Commission of Architectural Review

2. COA-128339-2023	Regular Agenda	Meeting Date: 4/25/2023
Applicant/Petitioner	William Brooks	
Project Description	Paint exterior of a previously painted masonry building dark blue.	
Project Location		
Address: 1642 West Grace Street		
Historic District: West Grace Street		
High-Level Details:	<p>Applicant proposes to paint the building dark blue.</p> <p>The building was previously painted yellow.</p> <p>The work has been completed and this application is the result of a violation issued on February 22, 2023.</p>	
Staff Recommendation	Partial Approval	
Staff Contact	Annie Delaroderie, annie.delaroderie@rva.gov , 804-646-6335	
Previous Reviews	None.	
Conditions for Approval	<p><i>Staff recommends denial of:</i></p> <ul style="list-style-type: none"> Blue paint of on the exterior of the house. <p><i>Staff recommends approval of:</i></p> <ul style="list-style-type: none"> Red, brown, or yellow-clay paint for the exterior. Final paint selections should be submitted to staff for approval.

Figure 2. View of 1642 West Grace Street in April 2023.

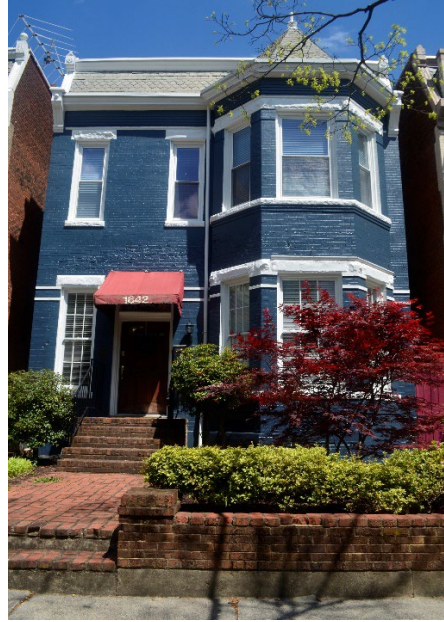
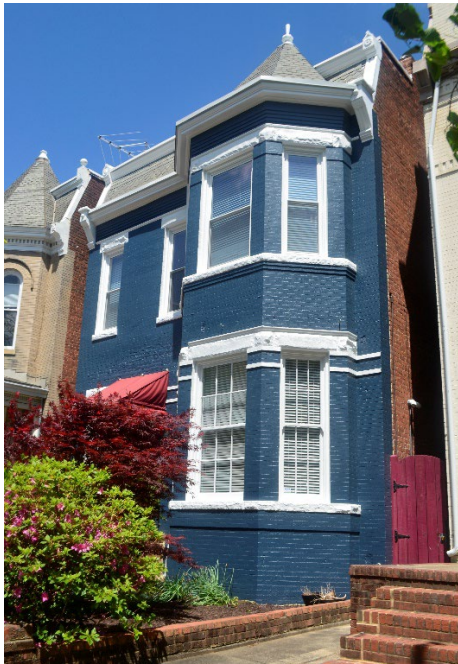
Guideline Reference	Reference Text	Analysis
Paint design guidelines, page 62	<i>Staff representatives of the Commission of Architectural Review (CAR) are authorized to assist Historic District property owners in paint selection, and where appropriate, grant Administrative Approval for paint color proposals...</i>	<u>The applicant painted his house dark blue, without approval of CAR.</u>

It is the assessment of staff that, with the conditions above, the new color of the house is in violation of the Old and Historic District Design Review Guidelines.

<i>Commission staff must approve any new paint colors before work can begin.</i>	
Paint Design Guidelines: HISTORIC MASONRY, page 63.	<i>1) Do not paint historic brick or stone masonry that has not previously been painted. Painting previously unpainted masonry is historically inaccurate and is not permitted. 2) Review is required if you wish to change the color of painted brick. If you wish to paint previously painted brick the same color, no review by staff or CAR is necessary.</i>	Because the building features previously painted masonry, the applicant can paint their house a new color, <u>but the building color should reflect a natural brick color.</u> The guideline keeps a continuity of brick buildings within historic districts.
Paint Design Guidelines: HISTORIC MASONRY, page 63, Masonry Buildings (previously painted only)	<i>3) Colors associated with the colors of natural brick are strongly encouraged and are preferable to less appropriate colors (white, green, blue). Paint Guide for Body Color- Brick: Reds, Browns, Yellow-Clay.</i>	The applicant proposes repainting the exterior of their house. <u>Since the house was previously painted, the owner could paint the building, but the paint color needs to be approved color found on the CAR Paint Design Guidelines for Masonry Buildings (previously painted only).</u>
